MEMORANDUM

FILE NO.: VAR2013 0007

PROPOSAL: A Variance to reduce the rear yard setback from 20 feet to 10 feet for construction of a single-family dwelling

Property Address: 540 W Eighth Street

PROPOSED SITE PLAN

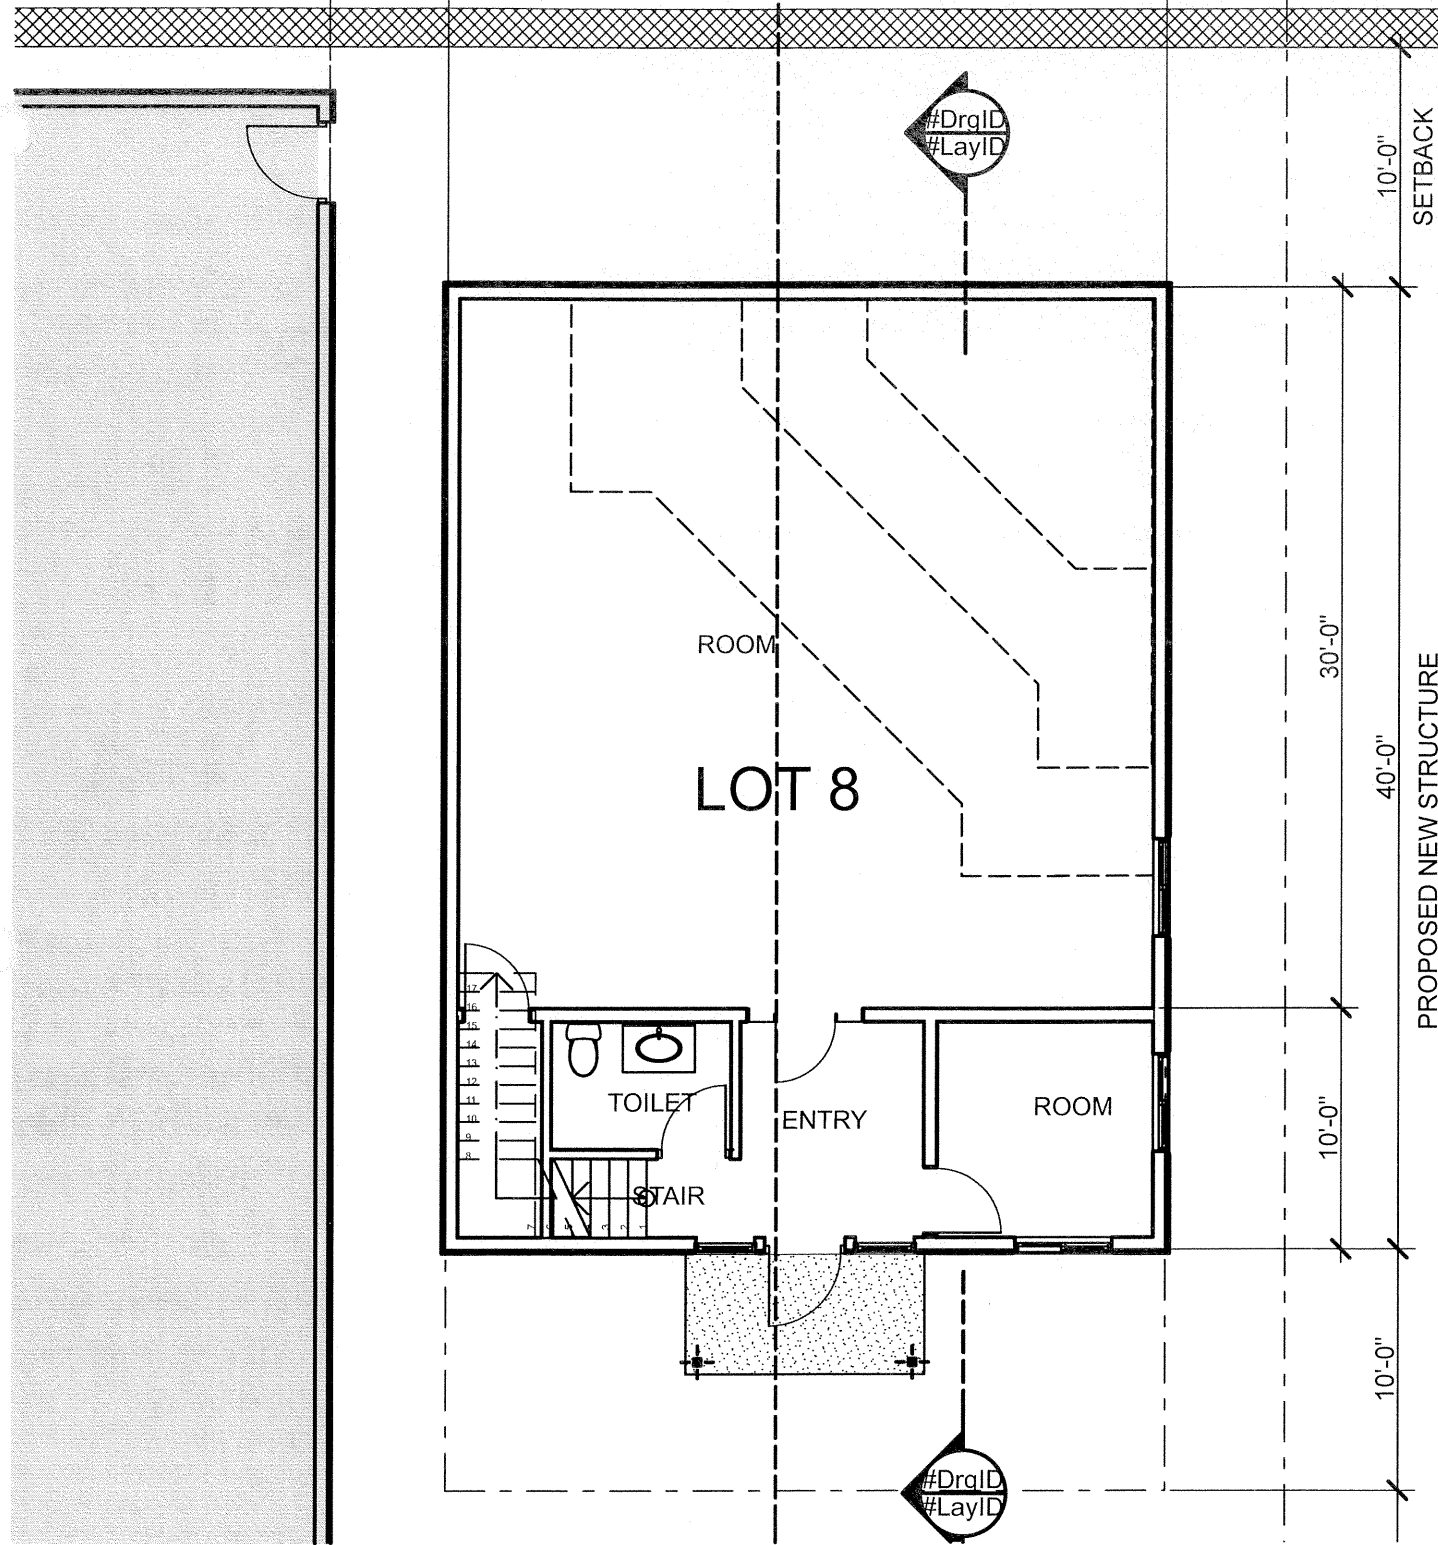
The applicant also requests the Variance to allow for three standard residential parking spaces on the lot. However, the CBJ Land Use Code requirement for a single family dwelling is two parking spaces, not three (Section §49.40.210). Two off-street parking spaces may be accommodated with minor adjustments to the proposed site plan, which would allow for the required 20 foot rear-yard setback and the 2,400 square foot home. A third parking space, if needed, could be accommodated on-street, which is allowed in this neighborhood.

Furthermore, it appears that if the four proposed parking spaces were moved all the way to the front property line, and approximately three feet was reduced from the length of the building, all spaces could be accommodated while meeting the 20 foot rear-yard setback. (Attachment 4, Site Plan)

Another option, which would retain the proposed parking configuration without any adjustment, would be to reduce the size of the dwelling by a larger amount to meet the 20 foot rear-yard setback. The reduction could compromise the owner's request for a 30' x 30' music studio. However, the primary principal use in the D-5 Zoning District is a single-family dwelling, which would not be compromised by the reduction. The music studio must be accessory to the dwelling to be an authorized use in the D-5 Zoning district.

Site Plan

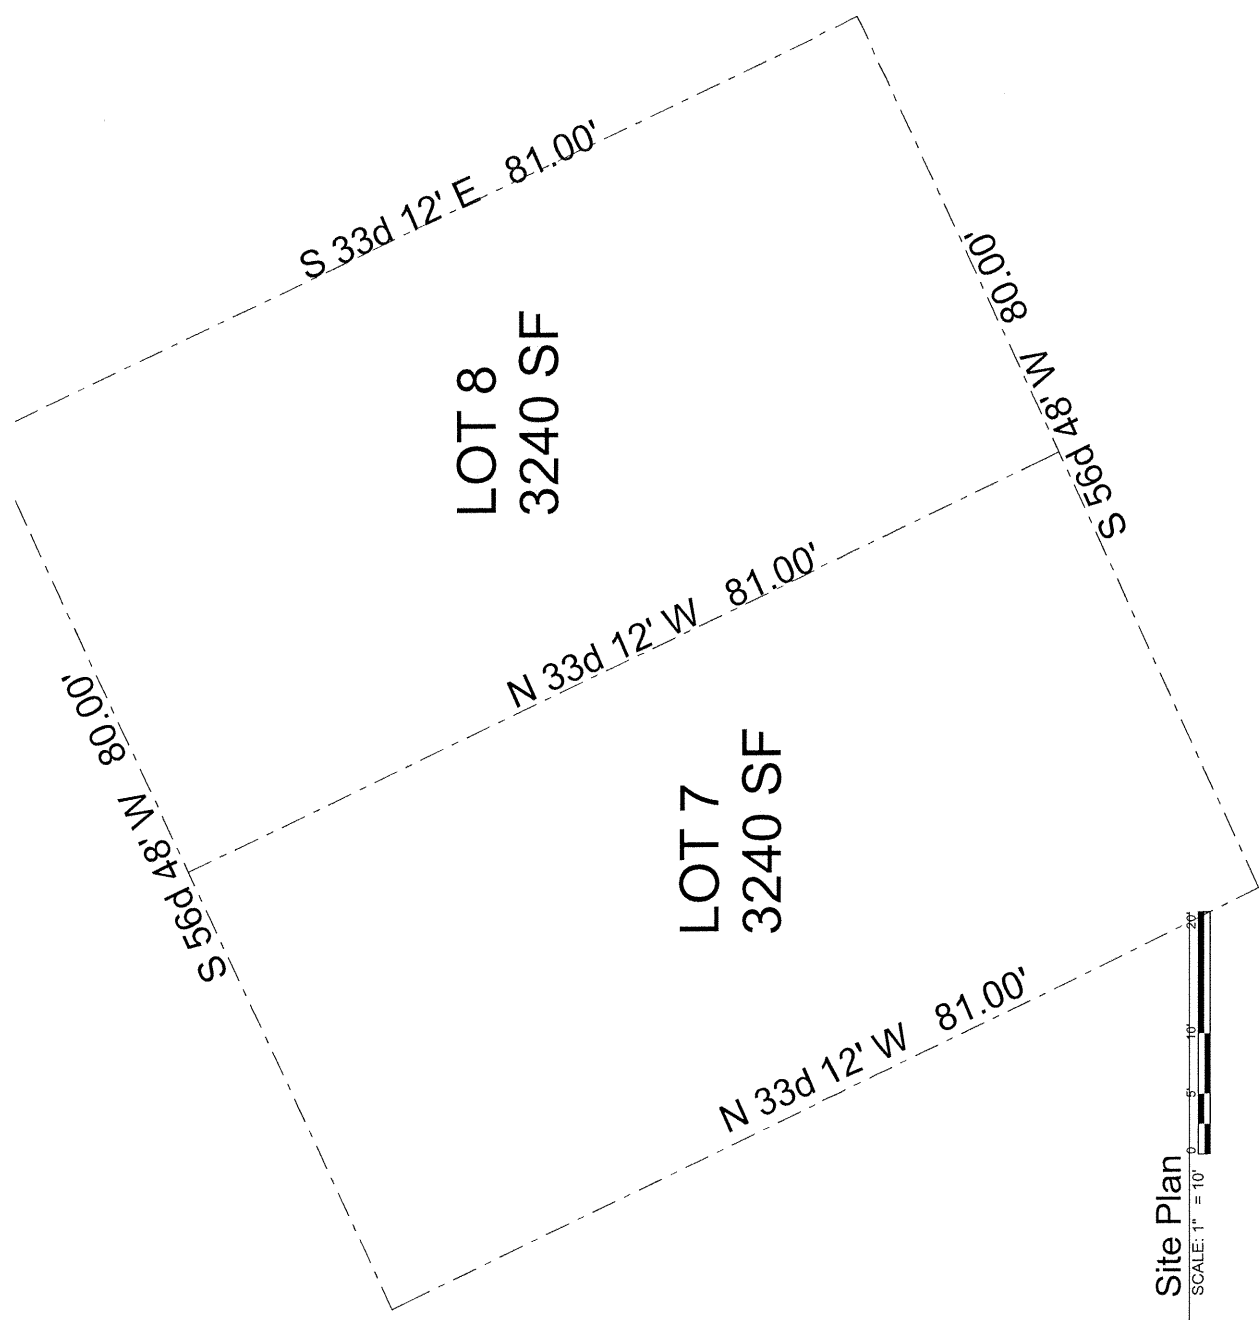
The applicant requests a Variance to reduce the required rear-yard setback from 20 feet to 10 feet in the D-5 residential zoning district for construction of a two-story, 2,400 square foot single family dwelling on a vacant lot, Casey Shattuck Block 212, Lot 8. (Attachment 6)
